PUBLIC INTEREST REVIEW FOR GROUNDWATER APPLICATIONS

SUBJECT: Application G- **18258**Supersedes review of **May 9, 2016**

A. GENERAL INFORMATION: Applicant's Name: **John Hickey** County: **Clackamas**

A1. Applicant(s) seek(s) **0.089** cfs from **1** well(s) in the **Willamette** Basin,
Molalla-Pudding subbasin

D. WELL CONSTRUCTION, OAR 690-200D1. Well #: 1 Logid: CLAC 10757D2. **THE WELL does not appear to meet current well construction standards based upon:**

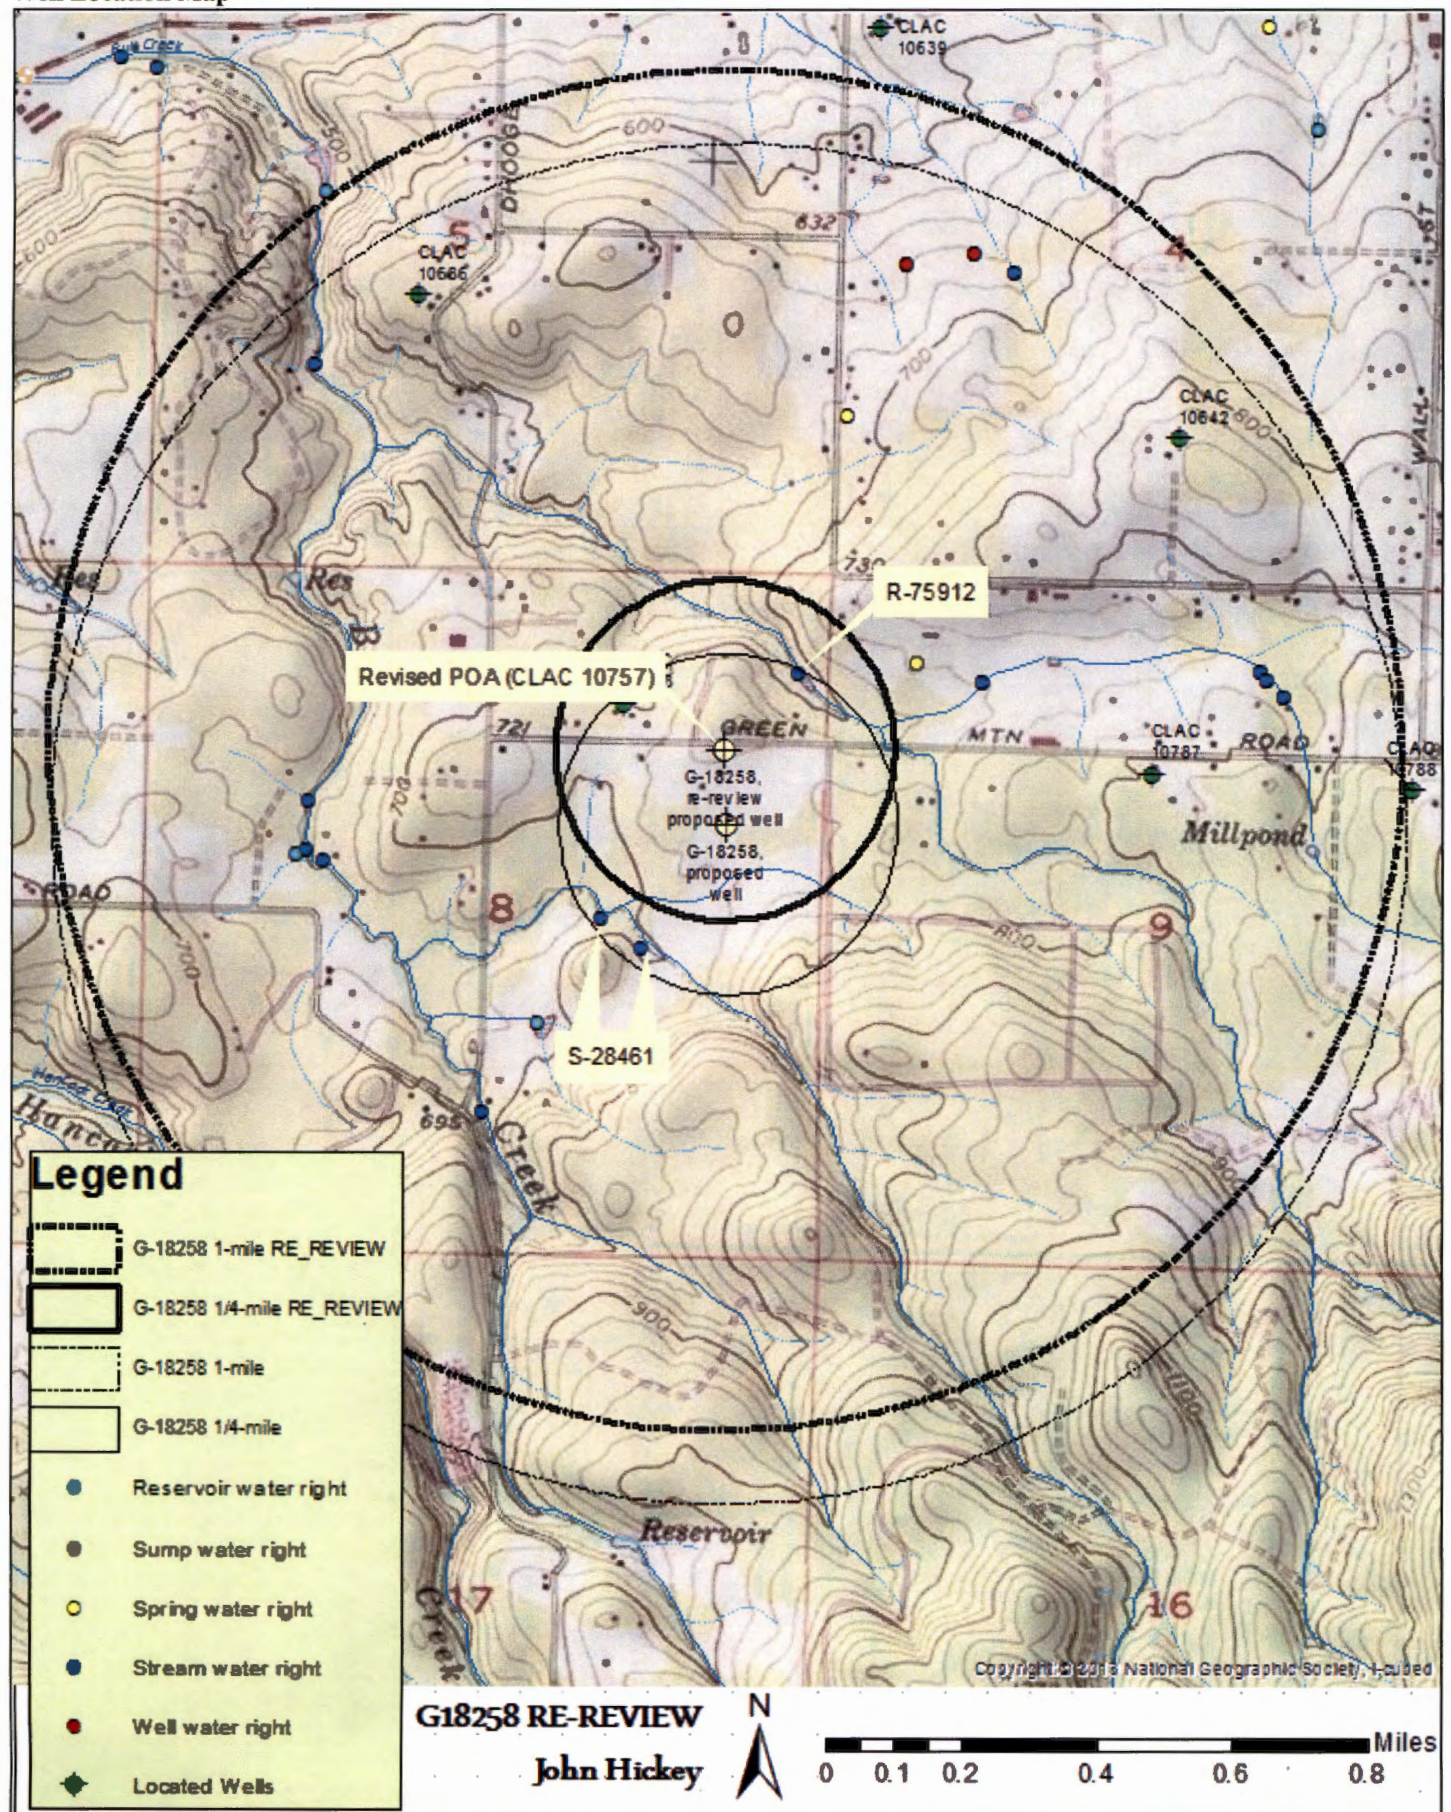
D3. **THE WELL construction deficiency or other comment is described as follows:** The well is cased and sealed from land surface to a depth of 20 feet. The well log indicates that it is producing from a confined sandstone layer from 307 to 321 feet below land surface. The log lists multiple layers of hard basalt with thickness greater than 50 feet overlying the sandstone.

D4. ☒ Route to the Well Construction and Compliance Section for a review of existing well construction.**Water Availability Tables**
